Subject: [FIXED] Beam pipe valves?

1) [viewer.gif](#), downloaded 1082 times

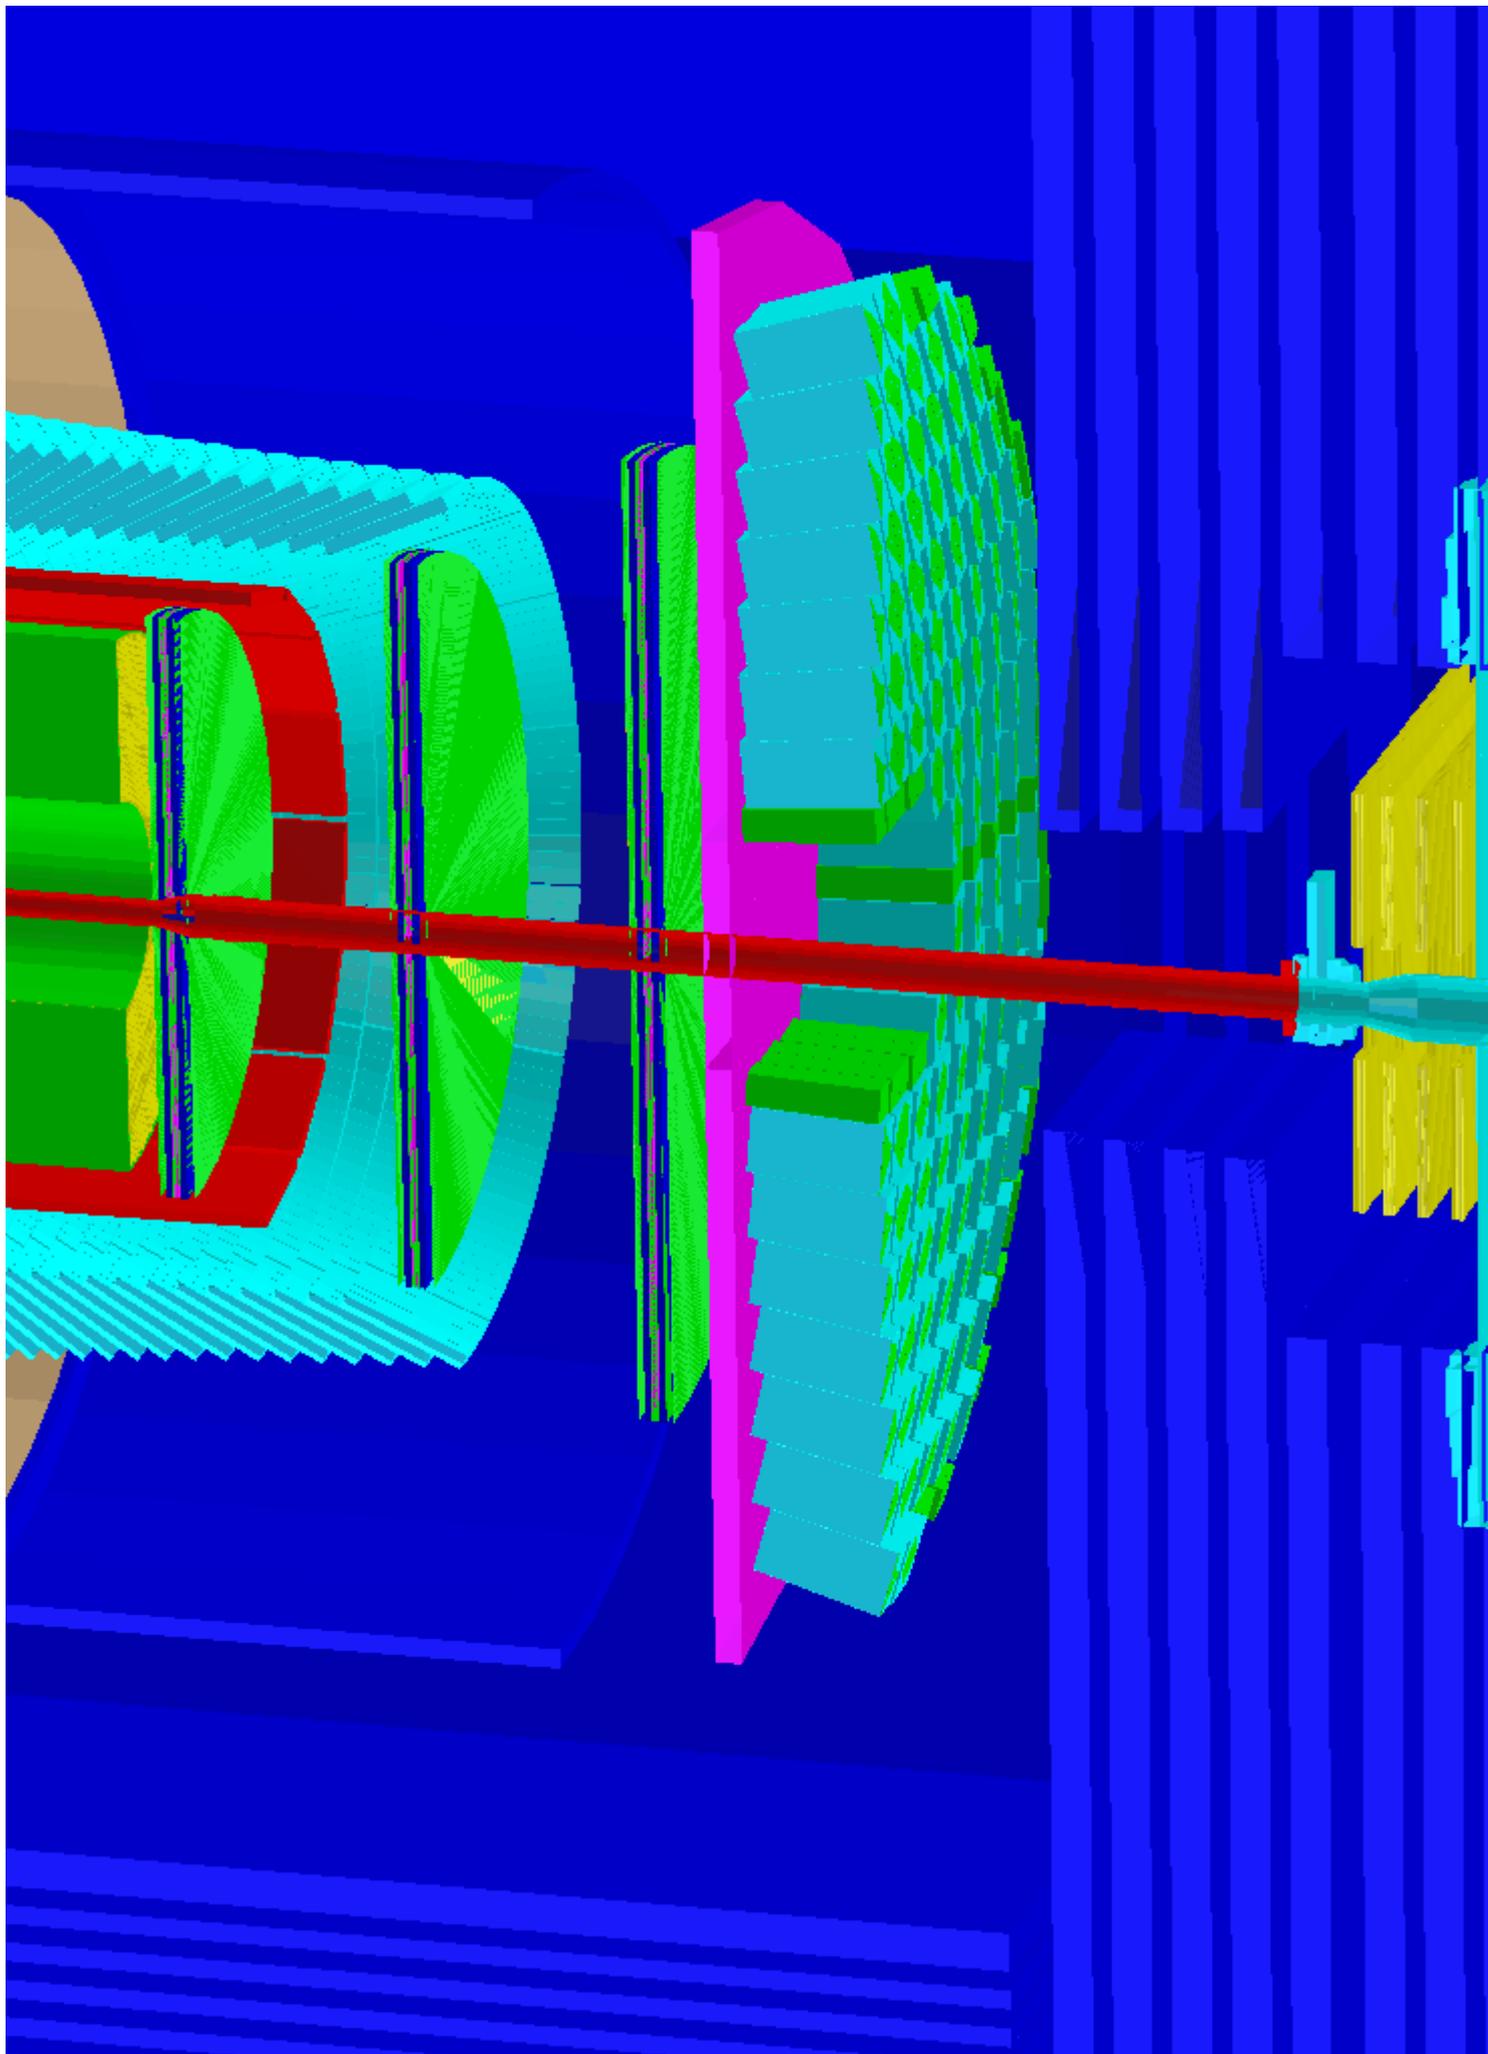
In the OGL drawing you can see that the pipe has a sort of "tower" which is in the middle of the muon filter. I am wondering what is wrong there, if the "tower" should be really there, if maybe the muon filter should be modified to host it, or if maybe we have some geometry problems.

Indeed, this is the first pumping station downstream of the target. The description corresponds to what is to be found on EDMS since several years. So I guess that muon description is not up to date?

Fixed!

Please update your mdt folder, in particular those running analysis on forward tracker.
